PATIO ADDITION & ACCESSORY PARKING LOT
FOR FITZGERALD'S RESTAURANT
173 WESTERN AVE N. and 401 SELBY AVENUE
ST. PAUL, MN 55102

REVISIONS - 5/6/2019

PROJECT:
FITZGERALD'S RESTAURANT
AND BAR PARKING
REVISION & PATIO
ADDITION

A1.0

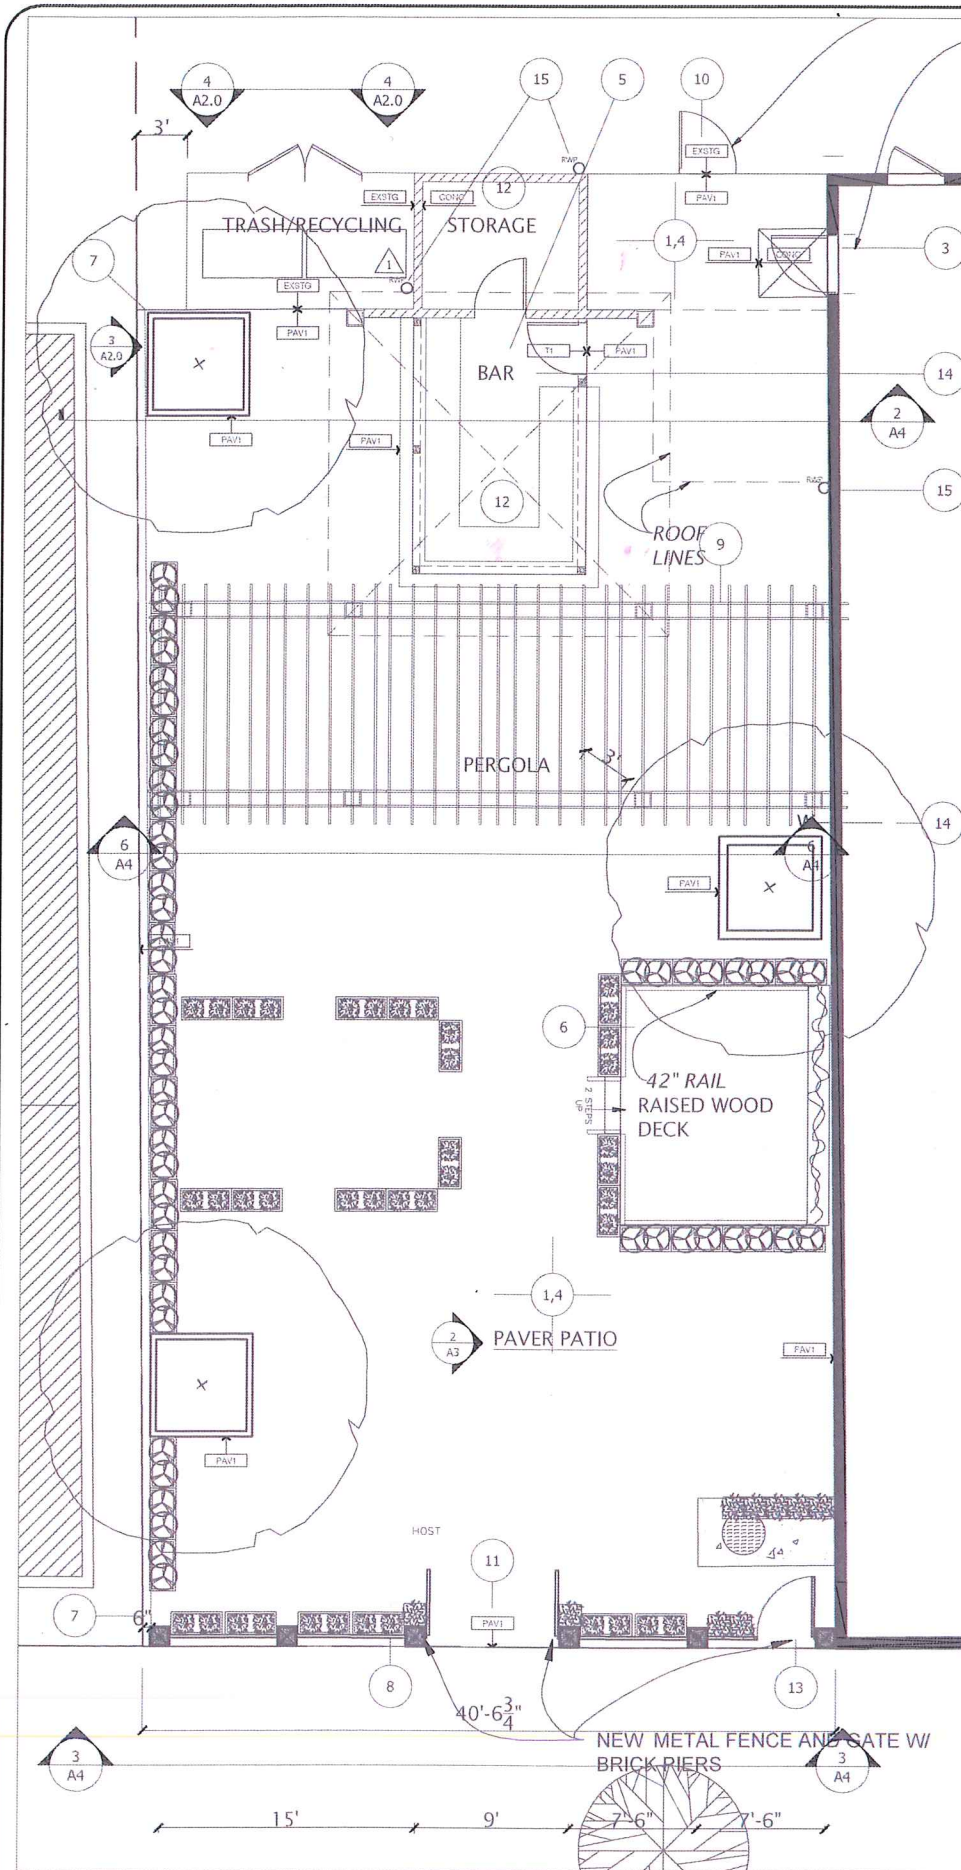
- 1 OPEN DOWNSPOUTS (RWP) LOCATED ON BAR AND CANOPY ROOF STRUCTURES, A1.0, A2.0
- 2 LAMP POST SPECIFICATIONS, A1.0
- 3 RELOCATED FENCE FOR SIGHT TRIANGLES, L1.0
- 4 SIGHT TRIANGLES, A1.0, C200
